Recall Bulletin

PRODUCT SAFETY RECALL

SUBJECT: Front Axle Right Half Shaft Fracture

MODELS: 2013-2014 Chevrolet Cruze
Equipped with 1.4L Turbo Engine (LUV)

Service Part Number 13371628 (Auto Trans)

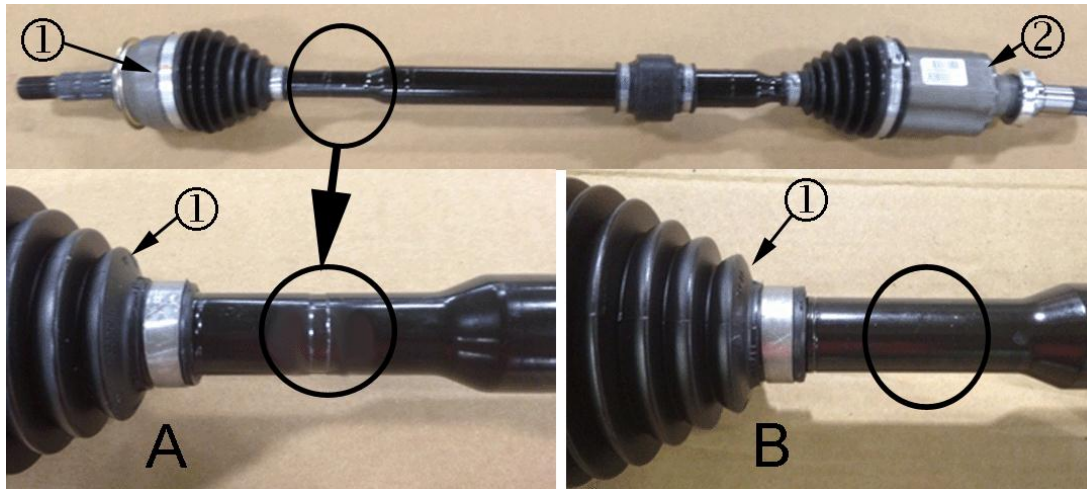
1. Inspect outboard side of the half shaft (longer portion of shaft between CV joint and isolator). Determine if a machined groove is present on the half shaft.
 - If the machined groove is present (A) on the half shaft, the part can be used for service.
 - If the machined groove is NOT present (B) on the half shaft, proceed to step 2.
2. Inspect the inboard side of the shaft (shorter portion between rubber isolator and boot) for a green stripe, green dot or combination of green stripe and green dot.
 - If these markings are present, this part can be used for service.
 - If no green strip, green dot, or green stripe and dot is present, this part should be returned to General Motors under special return bulletin G_000018785 dated March 18, 2014.

(1) Wheel Side of Half Shaft (2) Transmission Side of Half Shaft (A) Machined Groove (B) No Groove

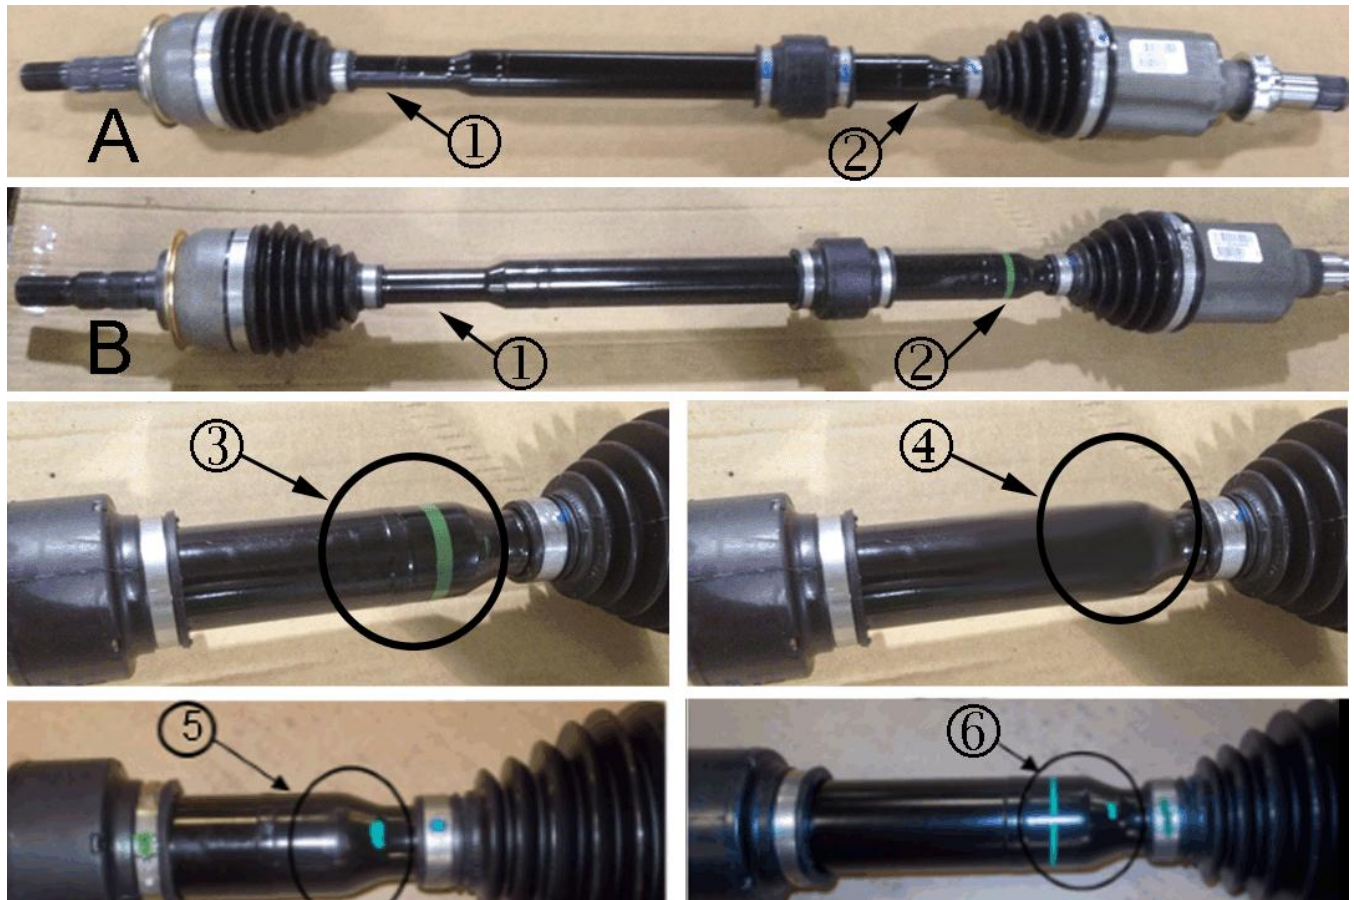
1. Raise and support the vehicle. Refer to *Lifting and Jacking the Vehicle* in SI.
2. Inspect the right (passenger side) half shaft near the front wheel. Determine if a machined groove is present on the half shaft.

- If the machined groove is present (A) on the half shaft, no further action is required. Lower the vehicle.
 - If the machined groove is NOT present (B) on the half shaft, proceed to step 3.
3. Inspect the right (passenger side) half shaft near the transmission. Determine if a green stripe, green dot, or green stripe and green dot is present on the half shaft bar.
